RECEIPT DATE: 2/5/18 **ONSITE SEWAGE DISPOSAL SYSTEM**

PROPERTY ADDRESS: 17741 Hardy Road

SUBDIVISION: Woodcamp Farms LOT: 25 TAX ID: 04-354605

ON SITE SEWAGE DISPOSAL SYSTEM DESIGN PLAN

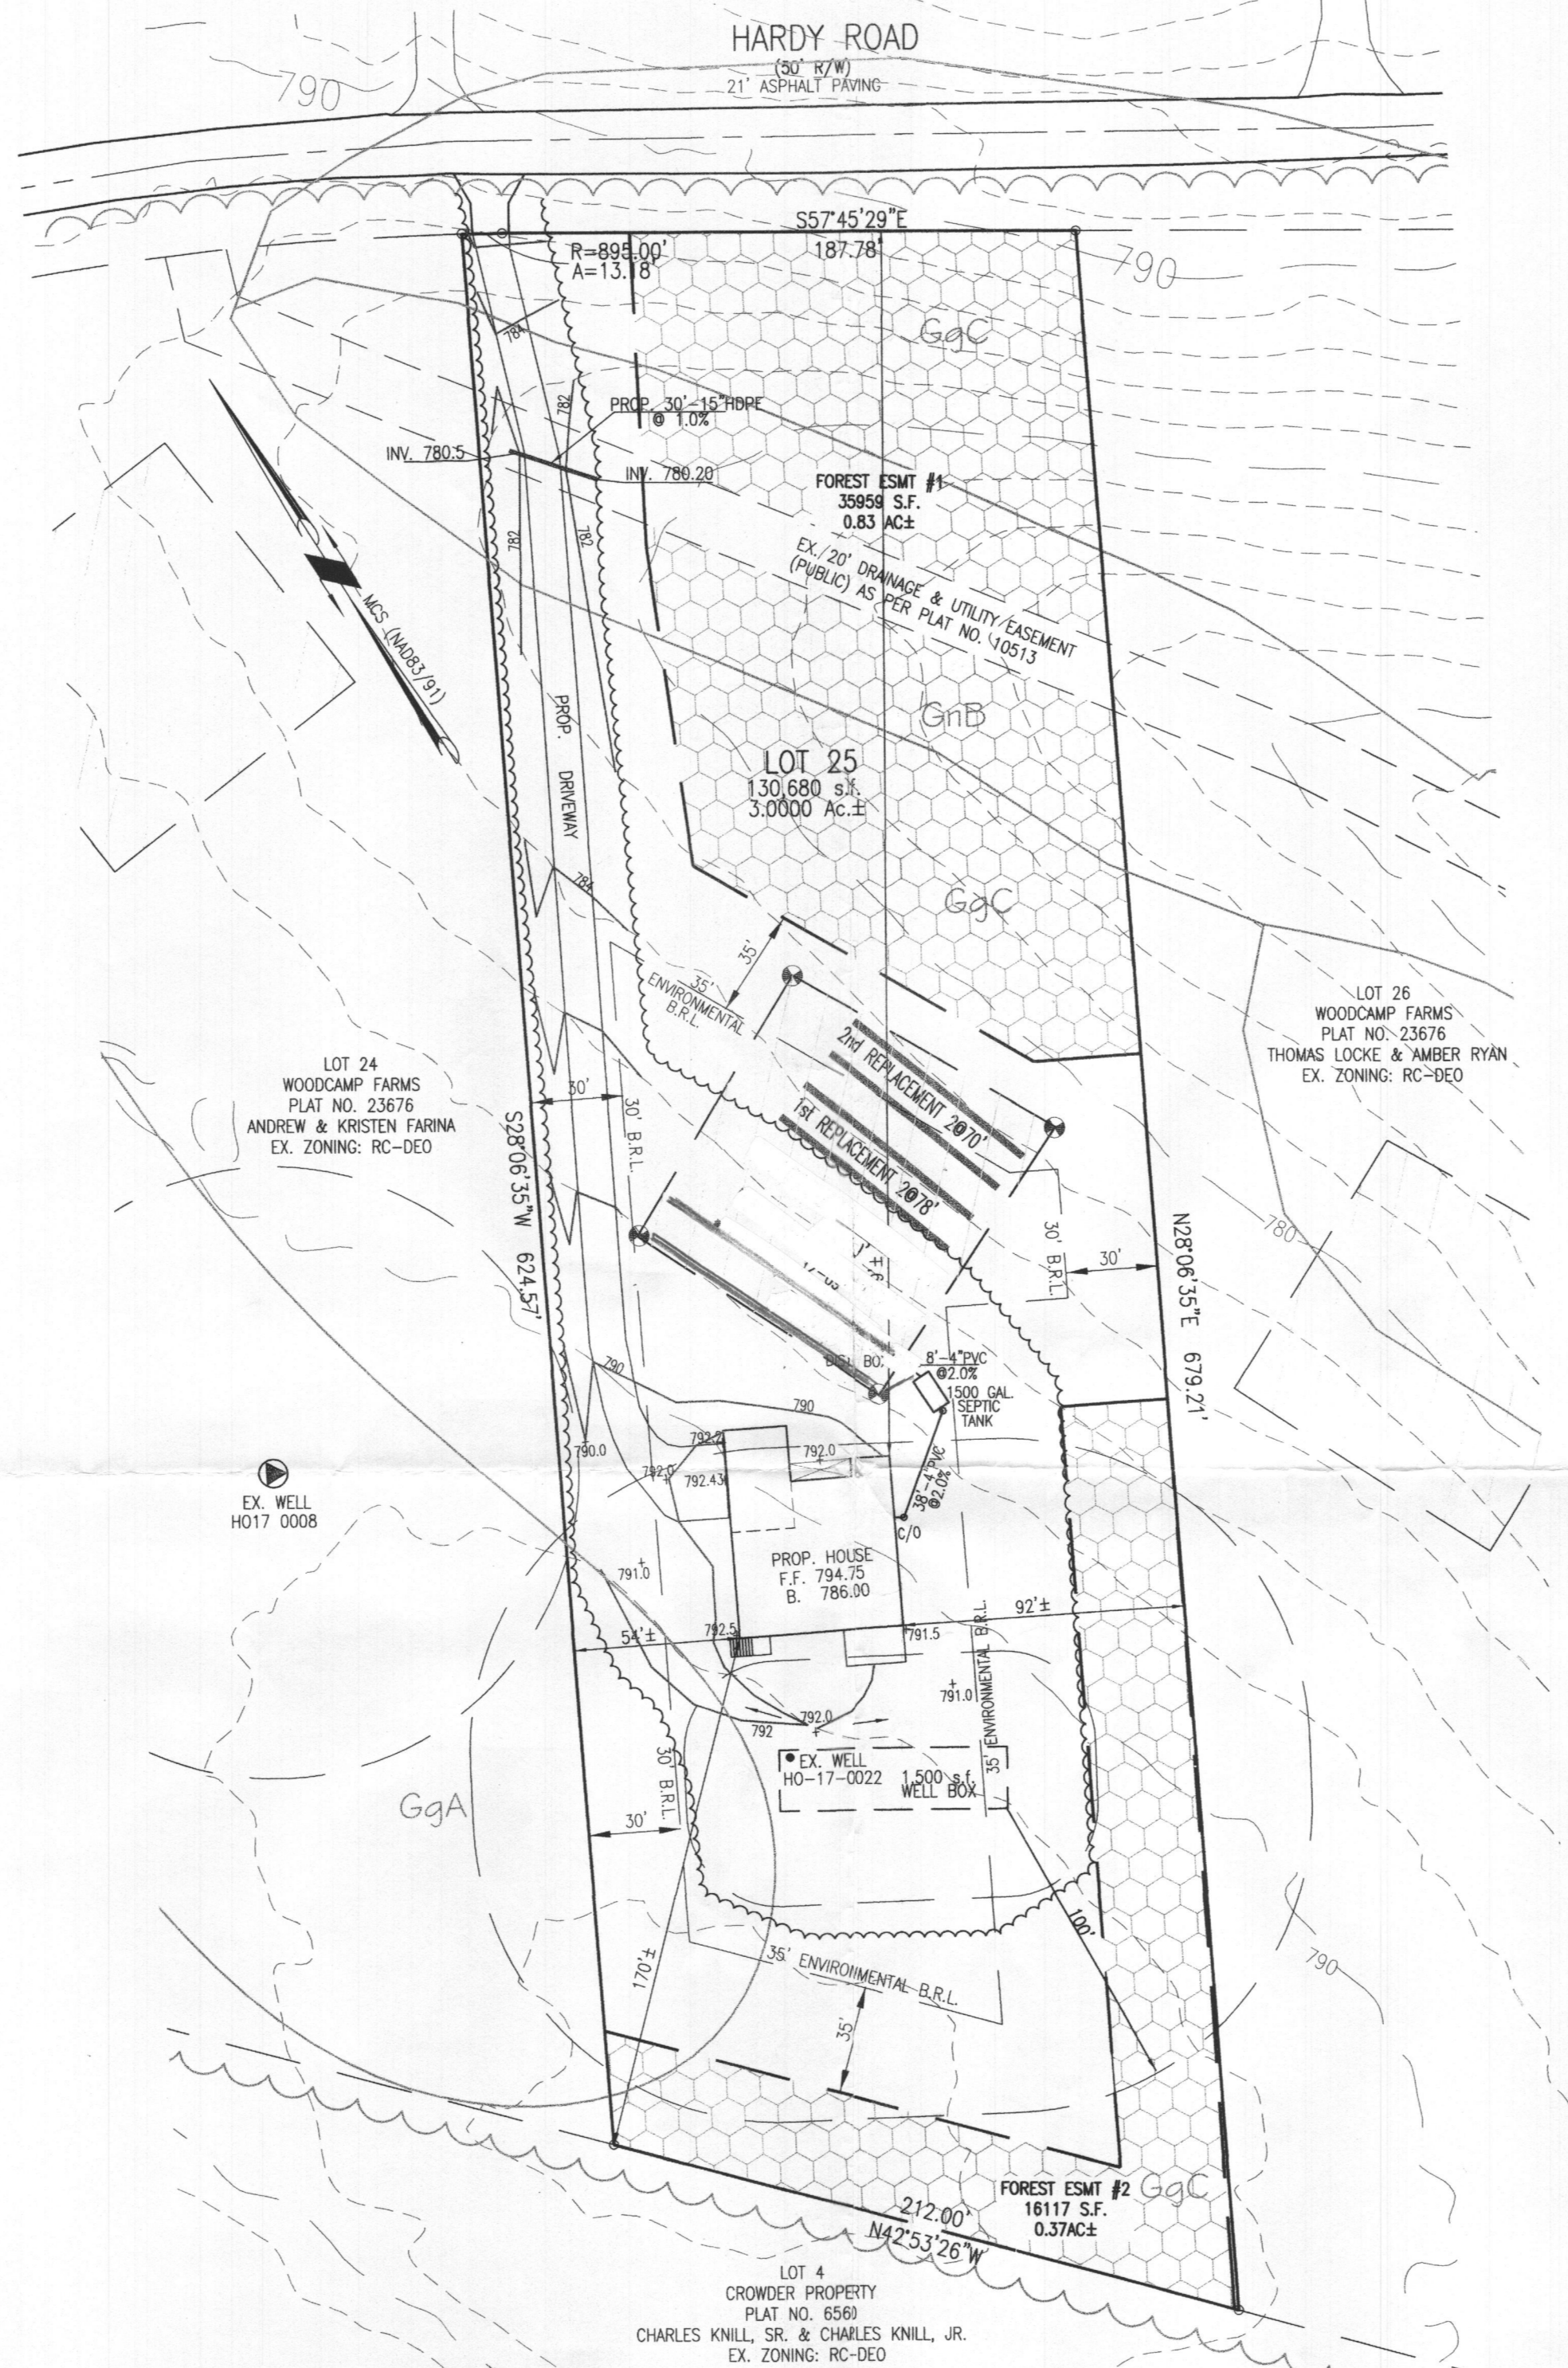
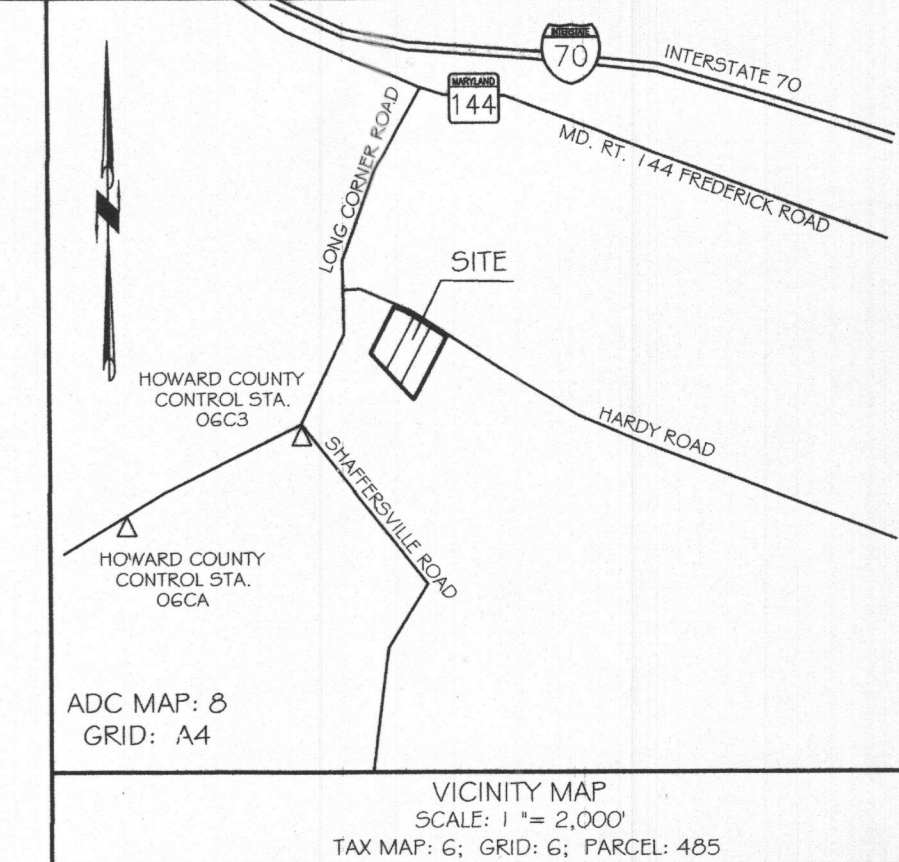
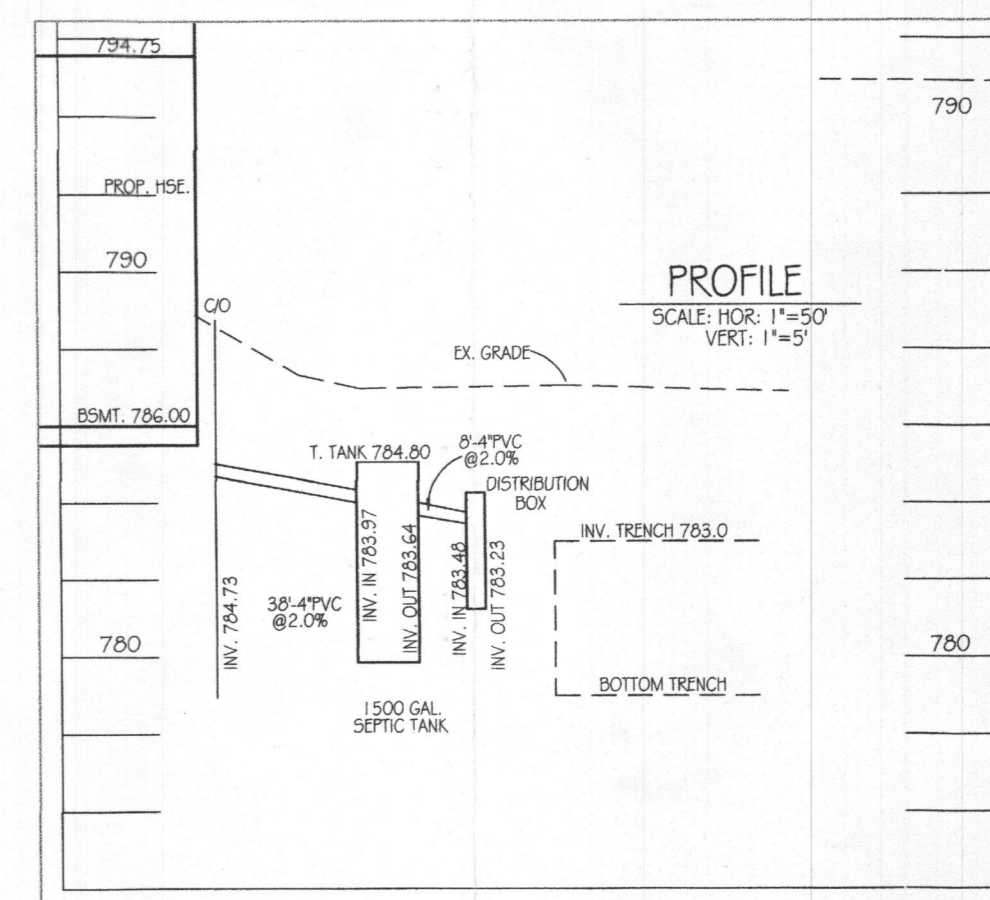
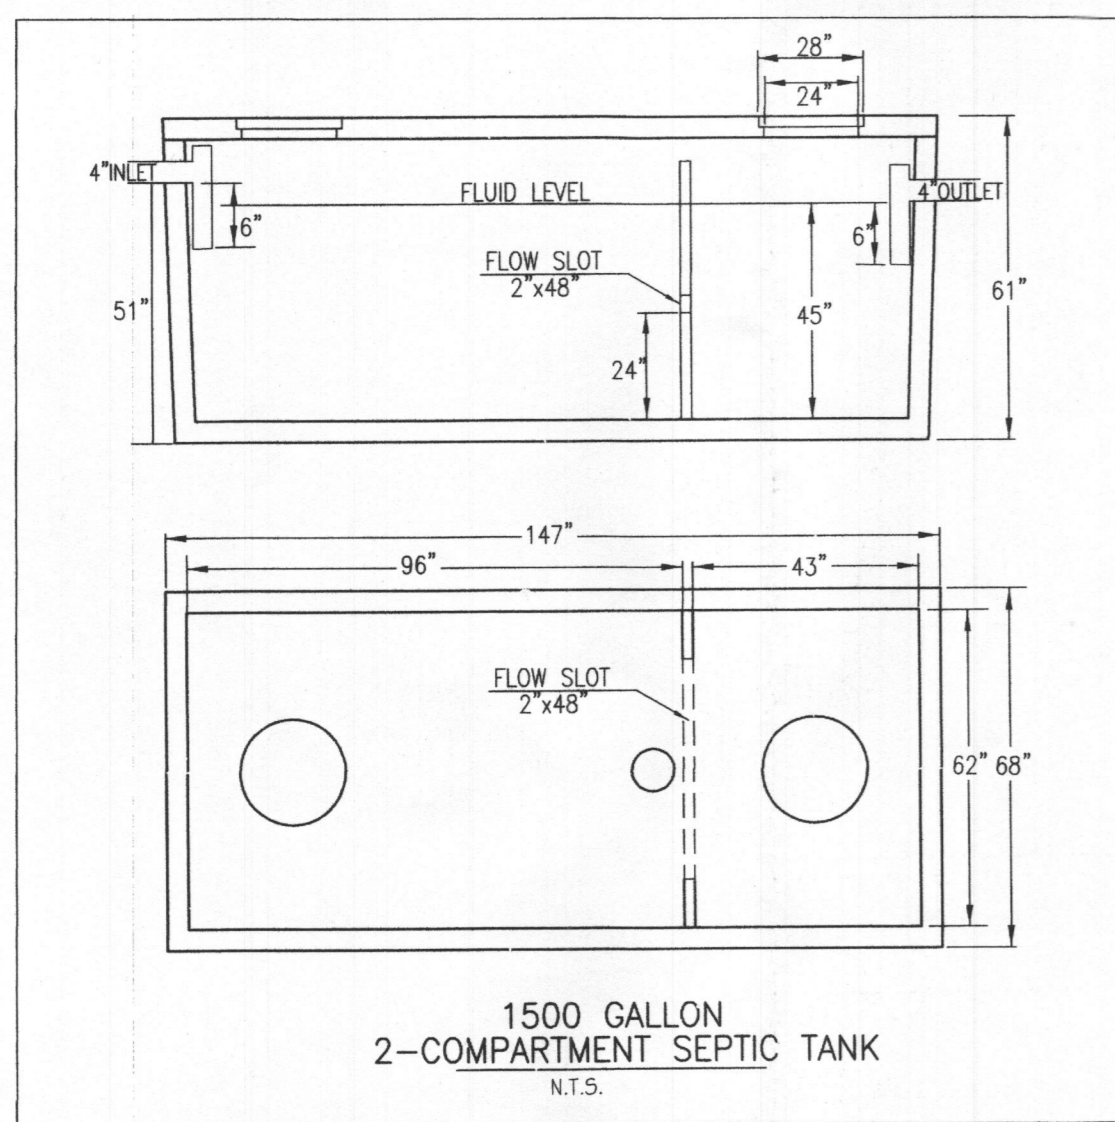
Good morning. I received a call from John P. who wanted to know about the status of the building permit for 17741 Hardy Road. I tried returned his phone call and left a brief message. At this point, we still need a revised OSDS plan showing the tank meeting the 20 foot setback to the house foundation. Also, there is a potential for a future bedroom in the basement so it might prove useful to size the septic system for 5 bedrooms (instead of 4). Lastly, I informed Mike awhile back that if the wall check included the covered porch as part of the foundation outline, we would not be able to issue the septic permit because the well box does not meet the 30 foot setback (I was looking for confirmation from him on this part of the project).

Good morning. The revised OSDS Plan shows the basement stairwell closer than 30 feet to the well box/well. Is there any way to shift the house so the setback can be met? This office will not grant a variance to the setback requirement for new house construction.

REMARKS: Hi Hank, plan revised to reflect basement entrance. Thank you!

1. The septic tank location has been revised to be 20-feet from the house.
2. The home owner will be eliminating a wall in the basement to eliminate a future bedroom in the basement. Therefore, the septic system remains a 4-bedroom system.
3. The covered porch will be on footers and will not be part of the wall check.
